Docket Item # 8  
BAR CASE # 2007-0195

BAR Meeting  
November 14, 2007

**ISSUE:** Alterations  
**APPLICANT:** Teresa M. Forster  
**LOCATION:** 702 Avon Place  
**ZONE:** RB/residential

Figure 1: Proposed rear elevation

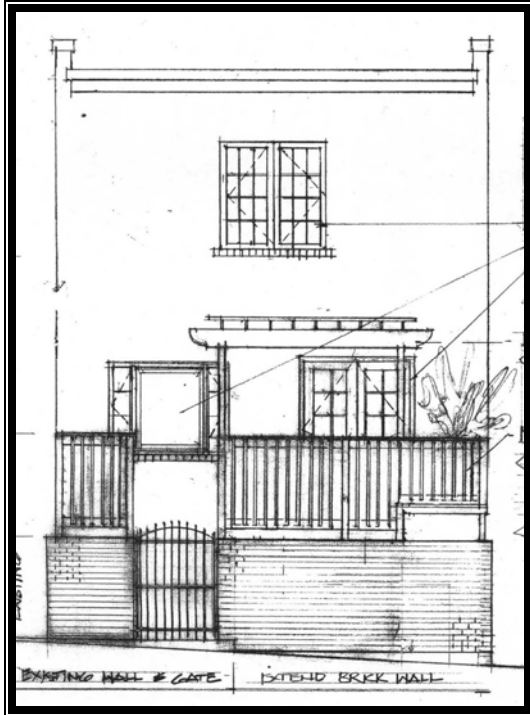
Windows and Doors – Only the second story window is original. Staff regrets its loss, but acknowledges that replacement of the nearly 70 year old window is warranted and exact replacement is impracticable. Based on a growing body of Board approvals for replacement of windows in the Fagelson’s addition neighborhood, either wood or aluminum clad wood windows are acceptable. The windows should replicate the light pattern of the original windows to the extent possible. The windows may be either true divided light or simulated divided light with spacer bars and exterior muntins. Staff has no objection to the configuration of the proposed replacement windows and door. All are compatible with the original architectural character of the house. As originally proposed, the windows were to be wood with true divided lights. According to a recent note to Staff, the applicant is now proposing clad, but has not specified whether vinyl or aluminum clad. In previous cases, Board and Staff have had no objection to aluminum clad, as the metal cladding is evocative of the original metal windows. However, vinyl would not be acceptable. It is not clear whether the applicant intends to change from true divided to simulated divided lights. Staff has no objection to simulated divided lights in this application as the windows are well removed from the public right-of-way. However, the simulated divided light should be the type that has both exterior muntins and a spacer bar.

1. That the extended brick wall be entirely on the subject property with the exception of the east side where it may continue as a party wall if the adjacent property owner agrees;
2. That the windows and door may be wood or aluminum clad wood and may have true divided lights or simulated divided lights, provided that they have both exterior muntins and a spacer bar; and,
3. That staff approve the final window and door selection.

Figure 2: Proposed rear deck plan

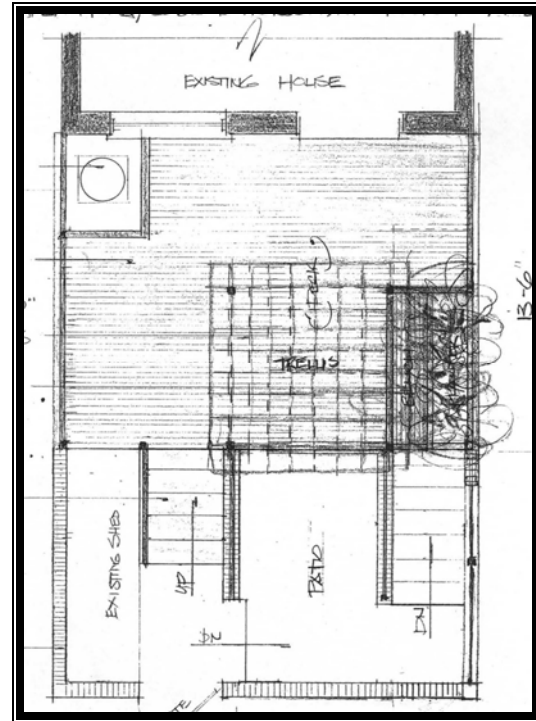
Wall - If the brick wall and railing on the east side is to align with the current party wall, the permission of the adjacent property owner is required. Otherwise the new wall/railing must be pulled back to be constructed entirely on the subject property. The south wall along the alley must be constructed entirely on the subject project.
